Product Change Notification: E-16-014614

PCN Date: 22-DEC-16

General Product Description:
AMPMODU MTE HEADERS GPL 296

Change in circuit cavity features

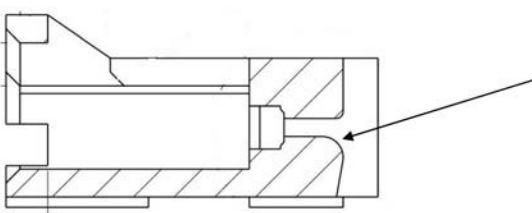
Description of Changes
To satisfy customer demand for the capability of MTE headers to handle RoHS solder temperatures, TE Connectivity has retooled the MTE header product line to use high temperature compatible LCP molding material. These changes will result in the following product changes: 1) Housing material will change from high temperature nylon to LCP. 2) The header housing width will be reduced by 0.005 inches to accommodate the assembly process. 3) In order to consolidate some housing features, the contact cavity configuration will be changed slightly as shown in the attached sketch.
